COMPANY: Skytc			
TITLE: JZ4755_DEV_V1.0			
CODE: <b>&lt;CODE&gt;</b>	SIZE: <b>C</b>	DRAWING NO: <b>JZ4755.sch</b>	REV: <b>1.0</b>
SCALE: <b>&lt;Scale&gt;</b>		SHEET: <b>0F</b>	<b>8</b>

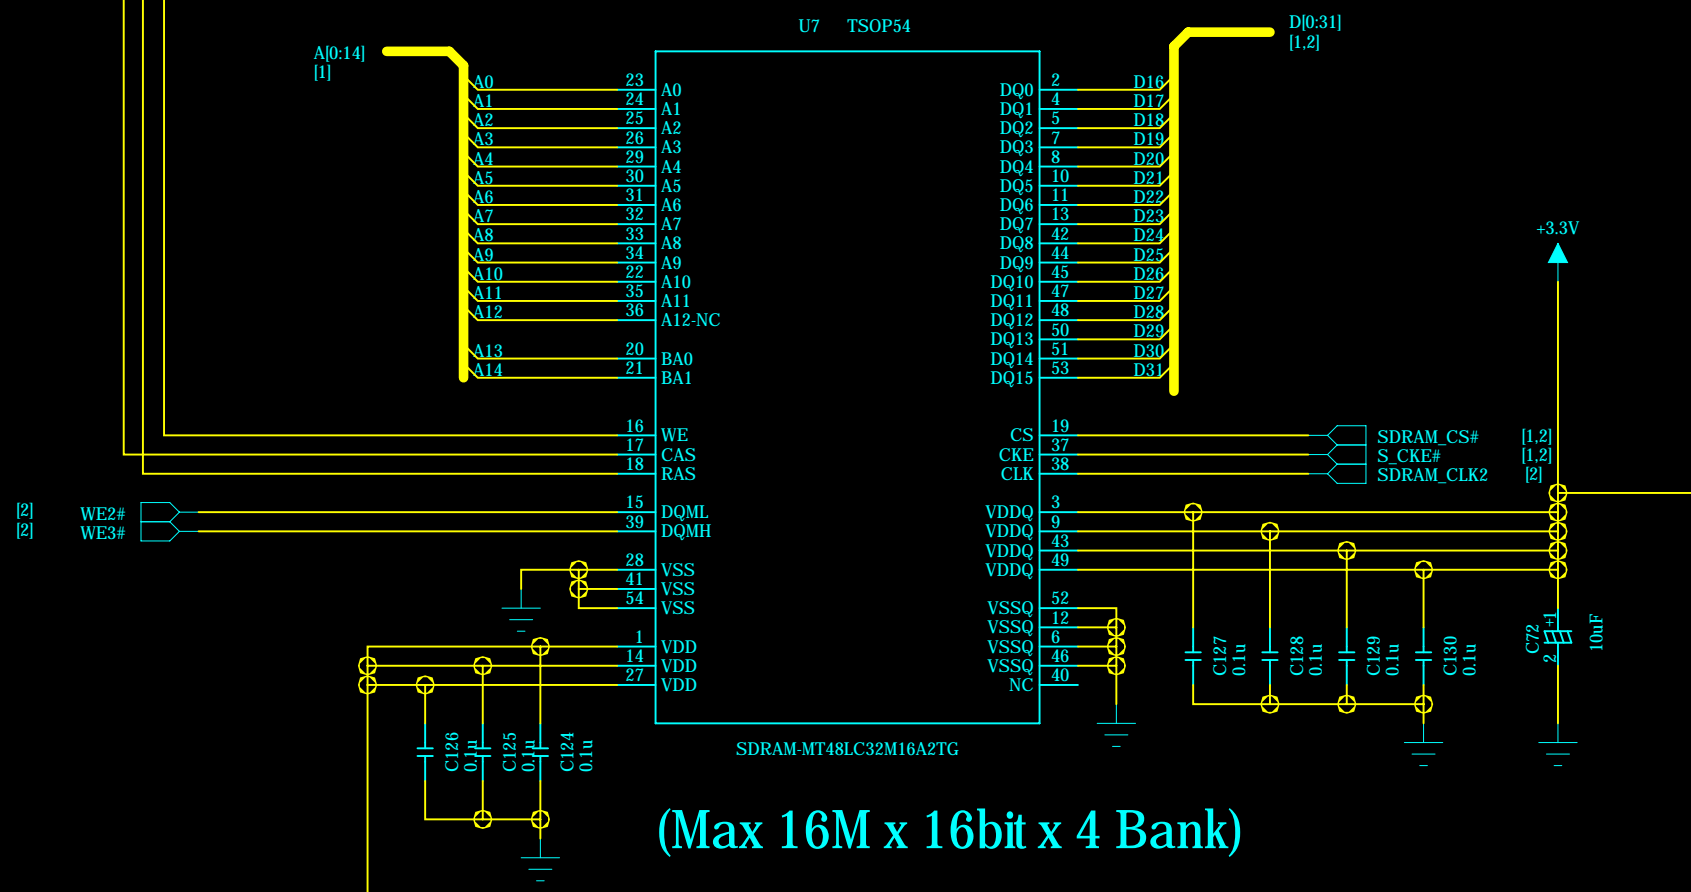
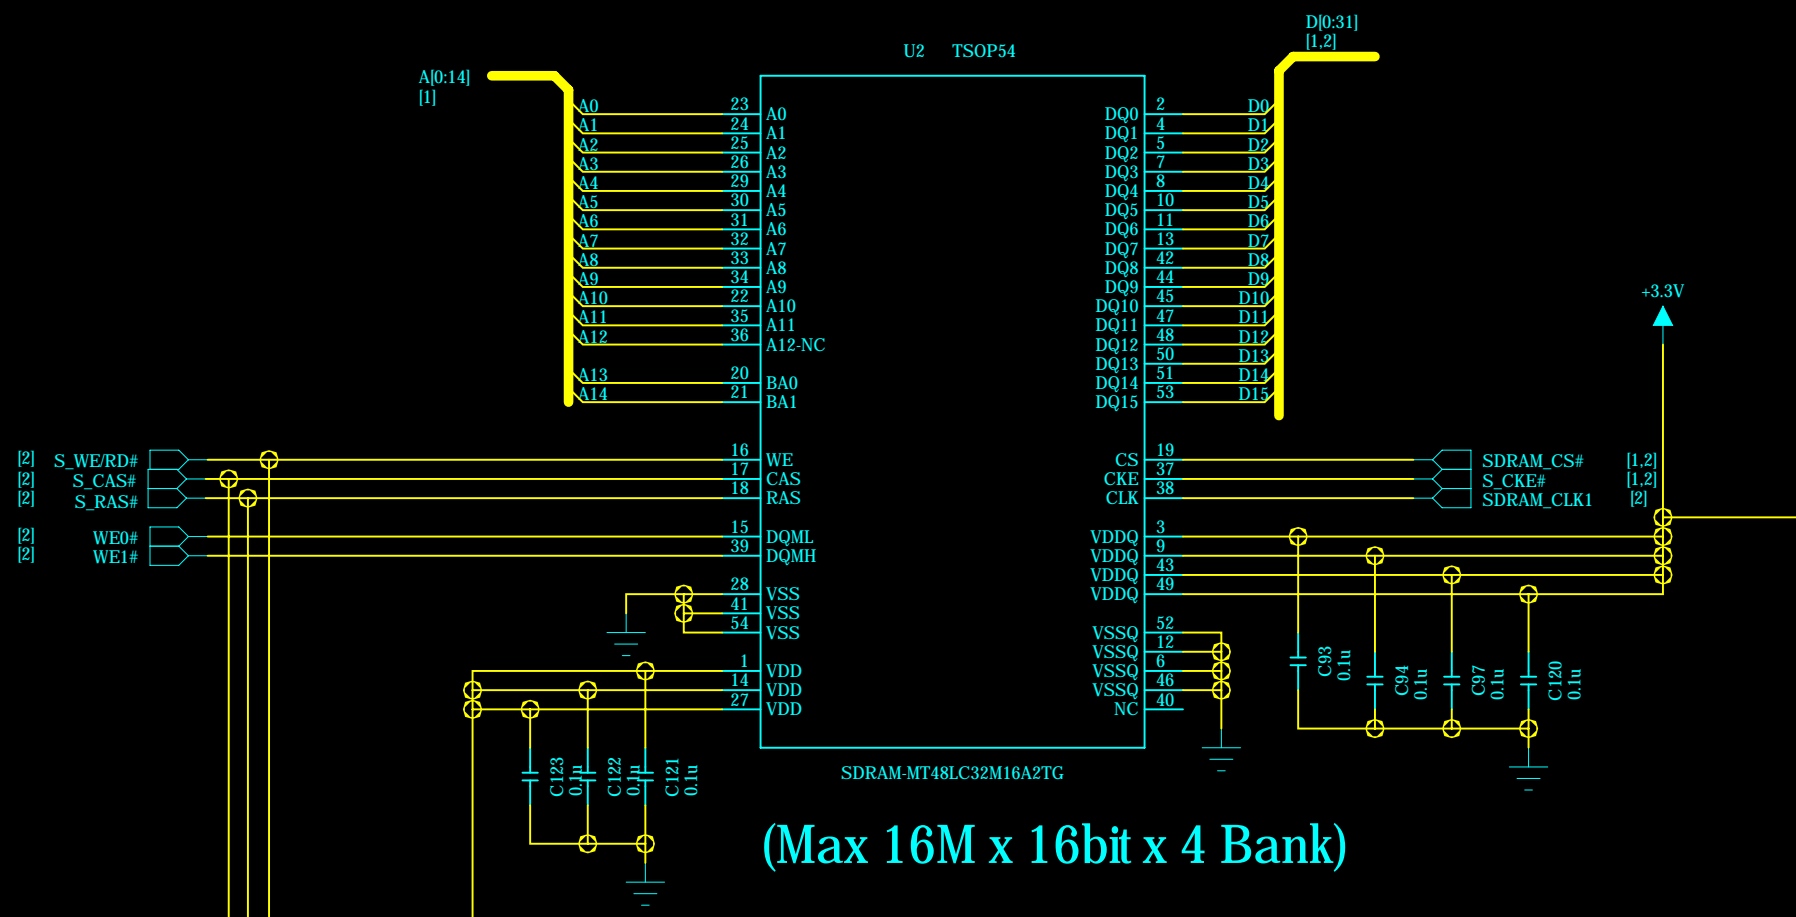
When Programing,J1 should connected.

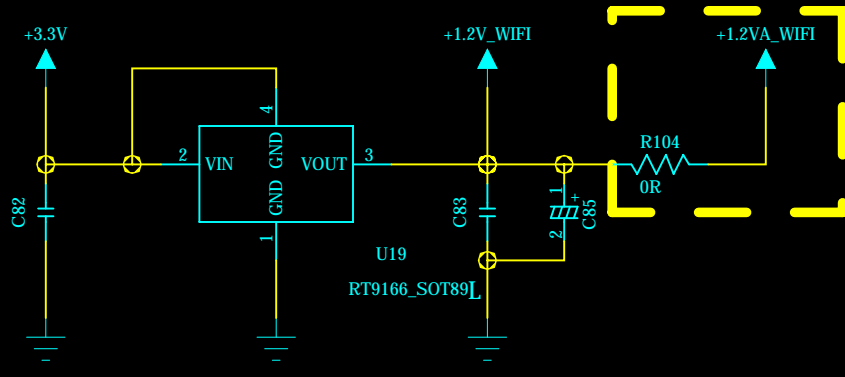
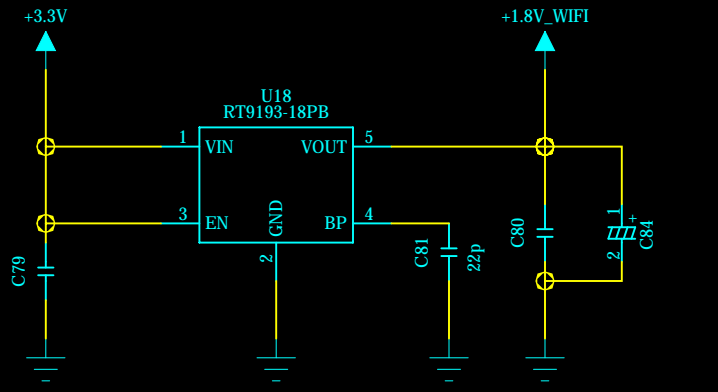
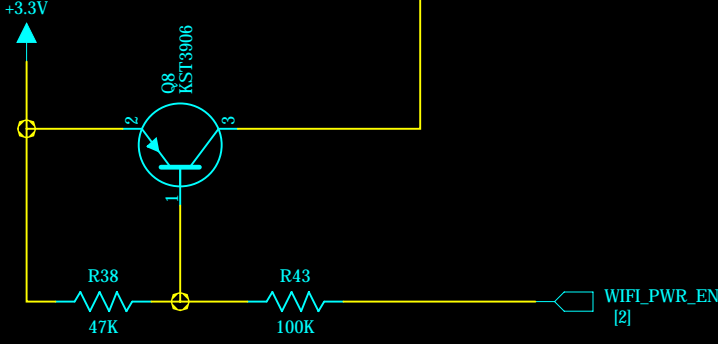
Note:The footprint should change to SOT89L  
The part number is RT9166A-12PXL  
Because the 1.2V is not a ultra low LDO,so it needed Add 10uF  
if not add,it will decrease the WIFI distance
